Addendum No. 2 Date: March 11, 2024

NEW FIELD HOUSE FOR THE JUNIOR VARSITY AT CENTRAL HIGH SCHOOL FOR THE CLAY COUNTY BOARD OF EDUCATION LINEVILLE, ALABAMA

MCKEE PROJECT NO. 22.304 ALABAMA DIVISION OF CONSTRUCTION MANAGEMENT NO. 2024009

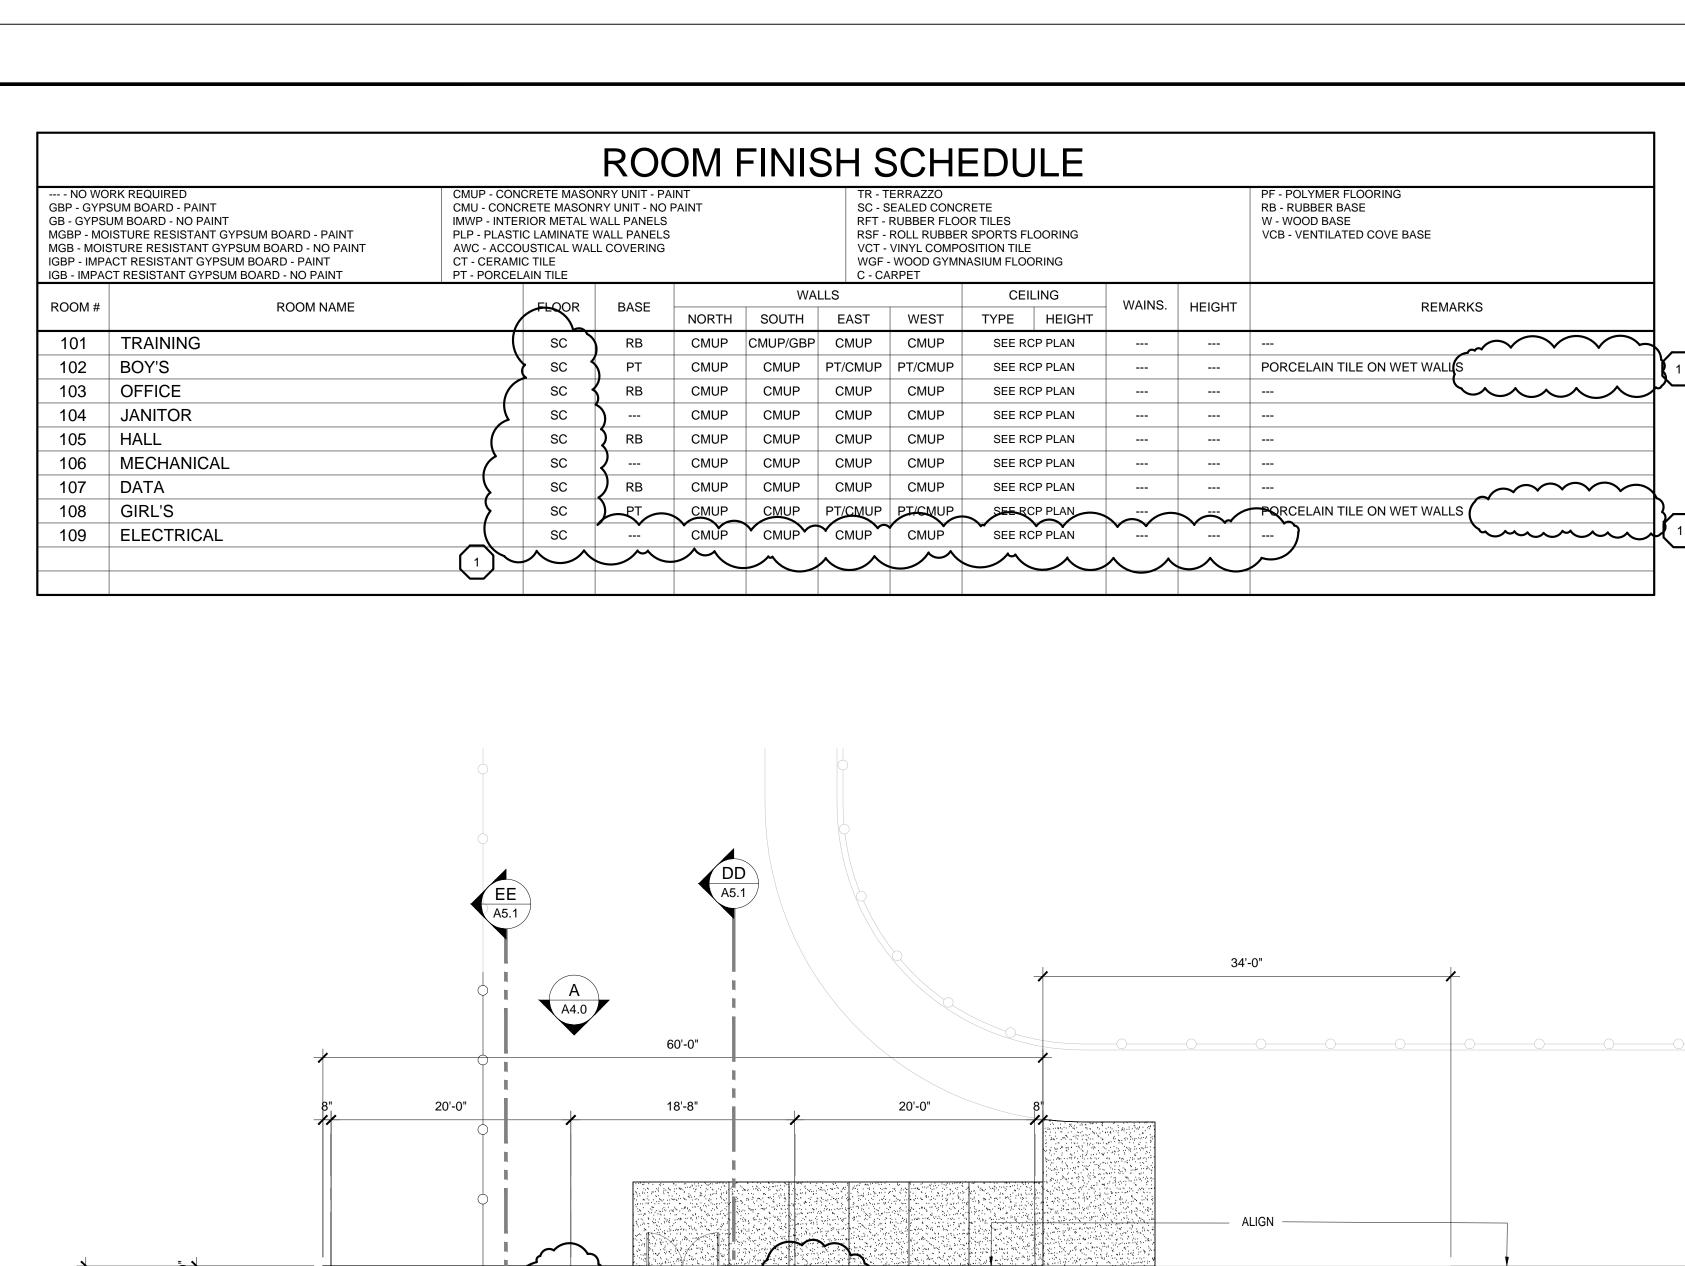
- 1) Refer to the Plans Sheet P2 and note the revised plumbing plan requirements.
- 2) Refer to the Plans Sheet M1 and note the deletion of sheet metal ductwork in the Training Room 101. Provide DuctSox as specified below.

PART 17. FABRIC AIR DISPERSION (DUCTSOX)

- 17.1. General: Non-metal ductwork, as shown on the plans, consisting of a noncondensing, fabric air dispersion product assembly. Product shall be classified by Underwriter's Laboratories and shall have a fire hazard rating not to exceed 25 for flame spread and 50 for fuel contributed and smoke developed as determined by ASTM E84. NFPA 90-A and are also classified in accordance with ICC Evaluation Service AC167 and UL 2518. All product sections must be labeled with the logo and classification marking of Underwriter's Laboratories. Manufacturer shall have and submit documented design support information including duct sizing, vent and orifice location, vent and orifice sizing, length, and suspension. Parameters for design, including maximum air temperature, velocity, pressure and fabric permeability, shall be considered and documented. Tensioning system shall be an IHS internal hoop system consisting of internal 360-degree hoop system spaced on 5'-0" centers for 95% full round tension in any airflow mode. System shall be installed with a one row suspension system located 1.5" above top-dead-center of the textile system. System attachment to cable or U-Track shall be made using Gliders spaced 12 inches. Provide 316 Stainless Steel components including coupler assembly. vertical cable support and Gripple quick cable connector. System shall be designed by the fabric air dispersion system Manufacturer to provide a maximum NC 35 sound rating at 6 feet above the floor. Provide all items necessary and required for a complete, finished and properly functioning installation. Duct Sox shall be provided with custom color, custom logo and custom wording. The Architect shall select color, wording and logo. Basis of design is DuctSox Verona. Equivalents by Durkee Sox Nano Model NSL with IRR support system, Prihoda or Fabric Air will be considered.

- **17.2.** <u>Textile Air Dispersion System:</u> Air diffusers shall be constructed with a metallic internal tensioning and skeletal system and of a woven fire retardant fabric that shall

be 100% flame retardant and treated with a machine wash-able anti-microbial agent from the Manufacturer. Fabric shall be a minimum of 6.8 oz. /sq. vd. per ASTM D3776 with custom color as selected by the Architect. The fabric shall operate within a temperature range of 0 degrees F to 180 degrees F. Fabric shall be coated with an antimicrobial agent shall be proven 99% effective after 10 laundry cycles per AATCC Test Method 100. Air dispersion shall be accomplished by vent nozzles as shown on the plans. Linear vent is to consist of an array of open orifices rather than a mesh style vent. Inlet connection to metal duct shall be via zip screw fastener. Inlet connection shall include zipper for easy removal and maintenance. System shall include adjustable flow devices to balance turbulence, airflow and distribution as needed. Flow restriction device shall include ability to adjust the airflow resistance from 0.06 – 0.60 in W.G. static pressure. End cap shall include zipper. Fabric system shall include connectors to accommodate suspension system listed. Each section of the textile shall include identification labels documenting order number, section diameter, section length, piece number, code certifications and other pertinent information. Any deviation from a straight run shall be made using a gored elbow or a high efficiency tee. Normal 90-degree elbows are five gores, and the radius of the elbow is 1.5 times the diameter of the DuctSox. Fabric diffusers shall be designed from 0.25" water gauge minimum to 3.0" maximum, with 0.5" as the standard. System overall design: diameter, length, airflow, operating static pressure and dispersion shall be designed and approved by the Manufacturer. Textile shall be warranted for 10 years.

- 17.3. Shop Drawings: Manufacturer shall submit for review, shop drawings indicating all sizing, fittings, attachments, dispersion pattern, etc. to achieve proper airflow at the design cfm and mounting height required for comfort and NC criteria specified. Provide sound analysis with submittal verifying NC ratings specified. Provide drawings indicating system design and certified performance rating. Additionally, supplier of the fabric sox material shall submit factory drawings, for review, showing the vent hole configuration with number and size of air outlet holes and spacing angles to adequately supply air to the floor based on the mounting height and locations of the fabric sox within each space.
- **17.4.** <u>Warranty:</u> Manufacturer must provide a 15-Year Product Warranty for products supplied for the fabric portion of this system as well as a Design and Performance Warranty
